McGuire Unit 2 Cycle 11  
Core Operating Limits Report  
July 1997

McGuire 2 Cycle 11 Core Operating Limits Report

**IMPLEMENTATION INSTRUCTIONS FOR REVISION 12**

Figure 5

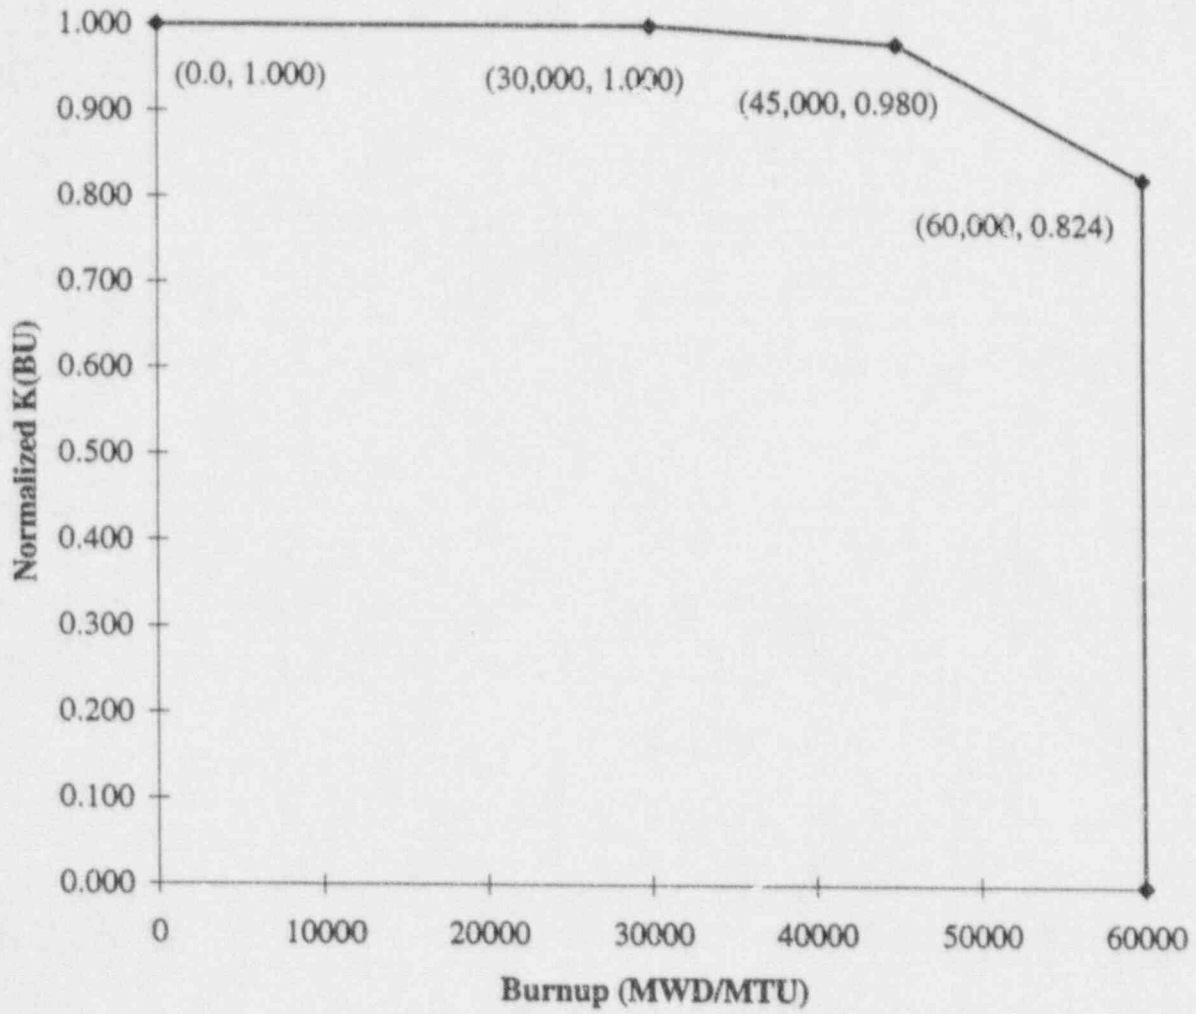
Revision 12 to the McGuire Unit 2 COLR is required to update the K(BU) versus burnup curve in Figure 5 due to changes in the LOCA limits due to errors in the vendor's LOCA analysis. The monitor factors in Table 1 in Appendix A are also updated due to these changes.
